PFISD Windermere ES, Northwest ES, and Provan HVAC and Control System Replacement

Prebid RFI's

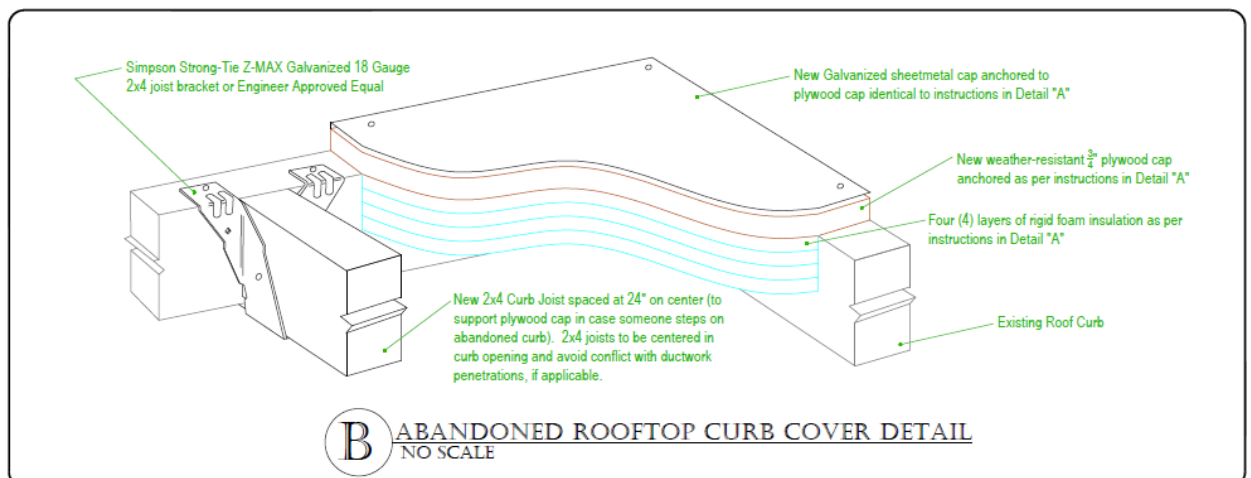
4. Sheet MEP1: Please Confirm if it is acceptable to use a curb cap to seal the openings left by demo of the two roof SF's and two roof EAH's above Play Area A122.

Answer: Yes it will be acceptable. Please reference the detail included below.

SIDE VIEW - NEW EXTERIOR PANEL DETAIL

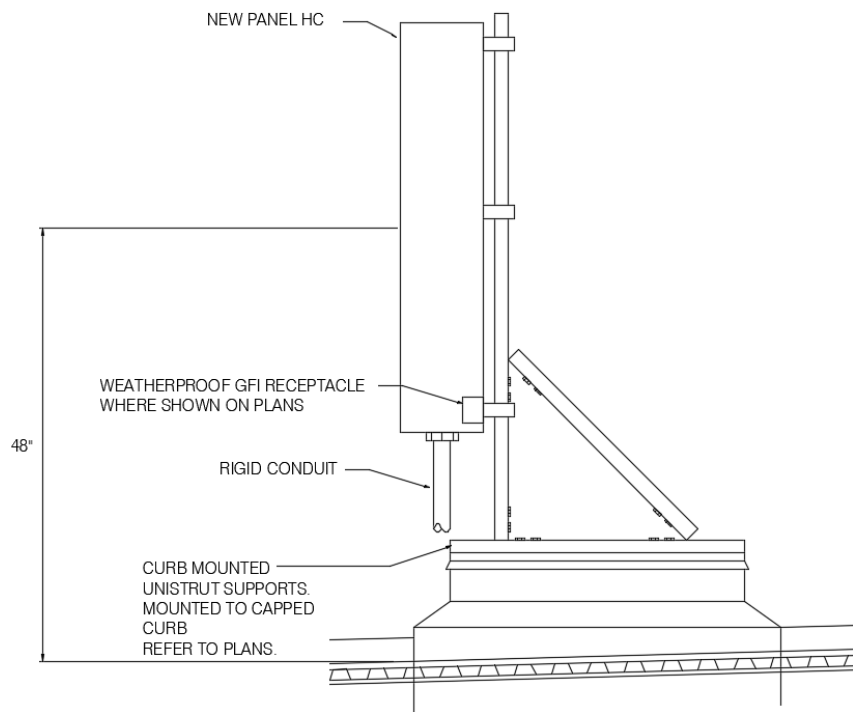
7. MEP Alt#1-6: Alt #1 New Roof Panel “HC” is shown to be a NEMA 1 indoor enclosure and location is not shown on Sheet MEP Alt#1-3 or Sheet MEP Alt#1-4. Please Confirm location and NEMA Rating of panel “HC”

Answer: It is shown on the drawing, but the keyed note for the panel to identify it was not. On Drawing ALT 1-3, at the plan northeast corner of the existing MZRTU-1 curb is a small box with supports shown connected to it. This represents the unistrut supports and Panel HC and corresponds to the existing electrical feeders and disconnect for MZRTU-1. As an exterior panel, it must be NEMA 3R or higher rated; please supply a NEMA 3R rated panel for new panel HC. See detail below.
